ENGINEERING CHANGE REQUEST (ECR)

CUSTOMER DRAWING NO. 972211

DRAWING TITLE BSC Downtube Weldment

REVISION: FROM F TO G

HYTEC, INC LIGC BSC DOWNTUBE WELDMENT		DR72211 D 2 of 5
ALL MACHINED SURFACES SHOWN	DR72211-1	2 of 5

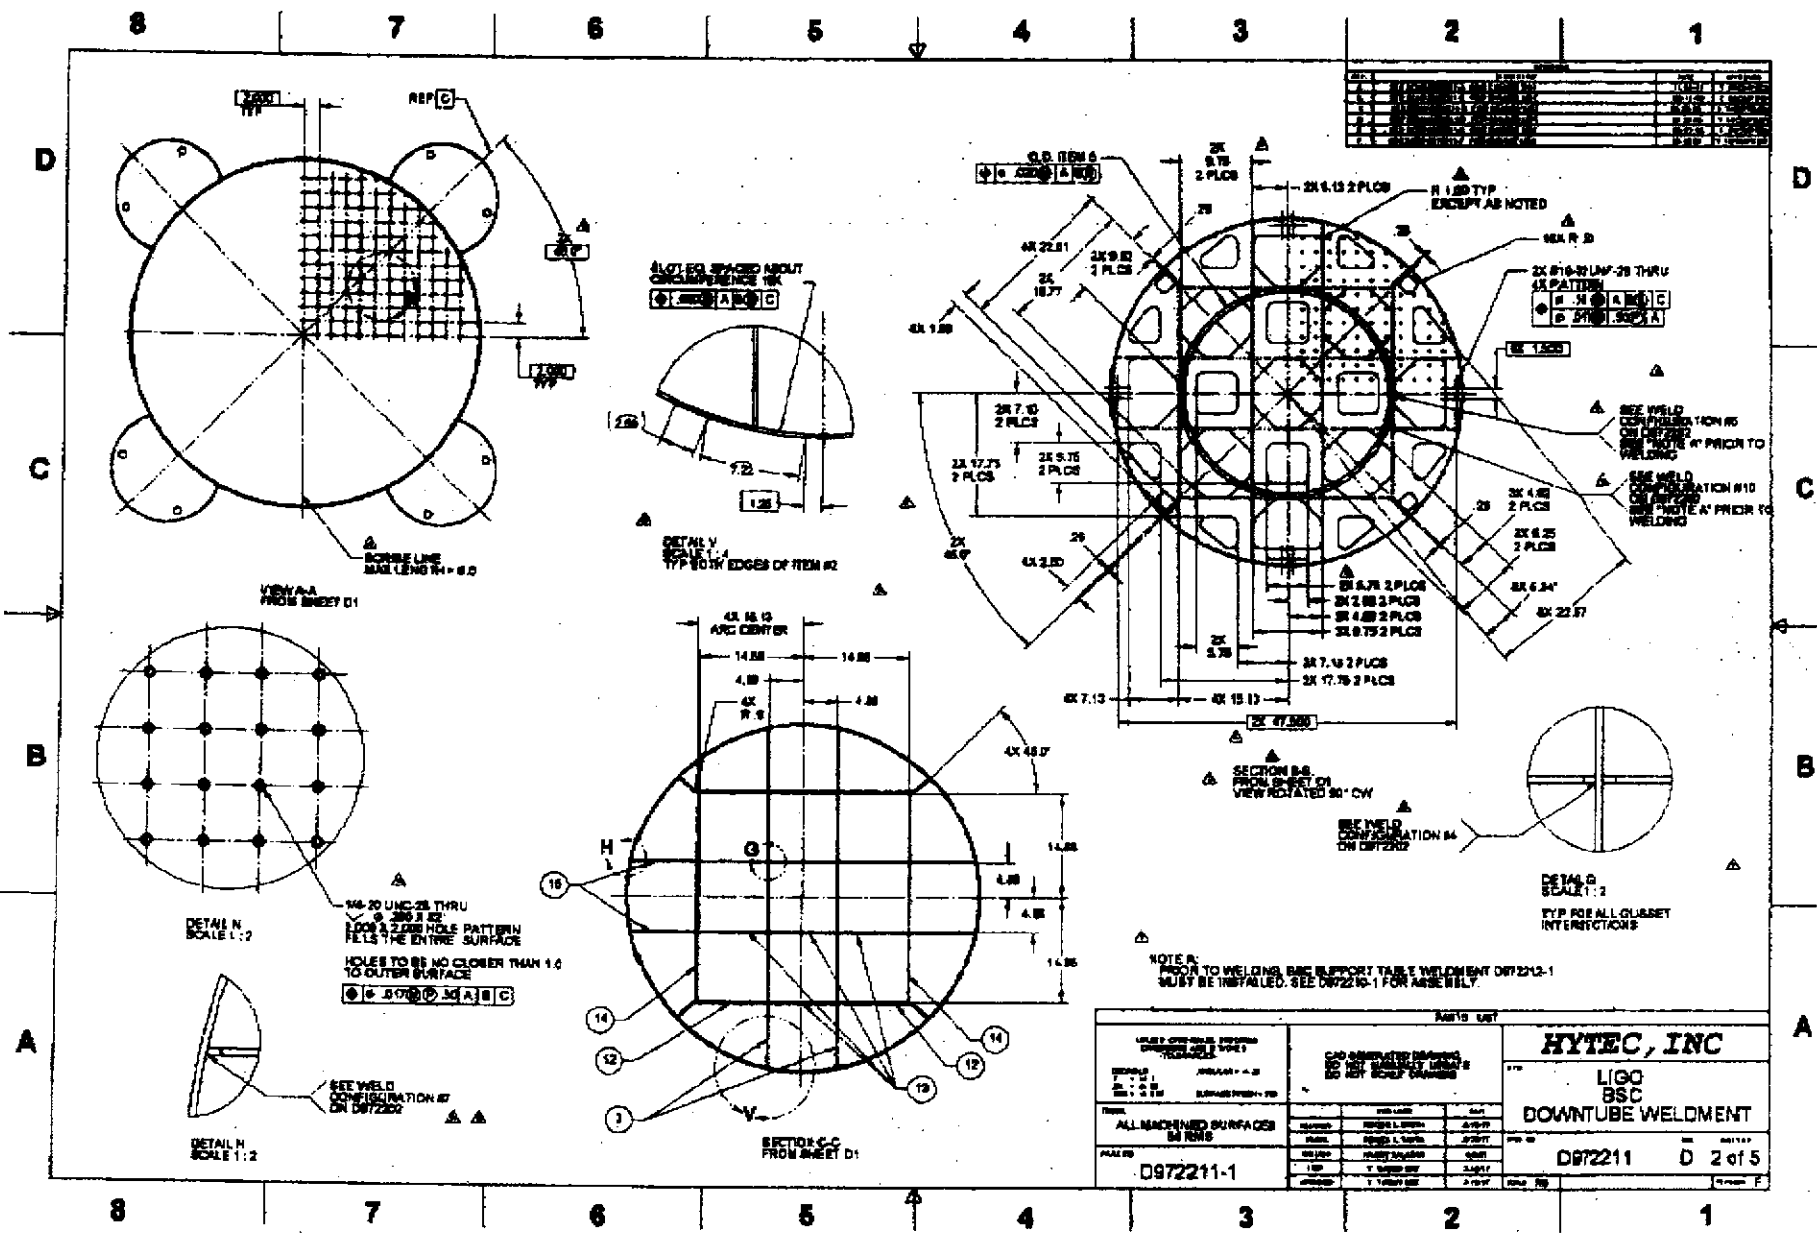
- Counter Sink on Optics Surface was $\phi = .39$ change to standard sheet tolerance

- Eliminated $1/16$ grooves used for venting
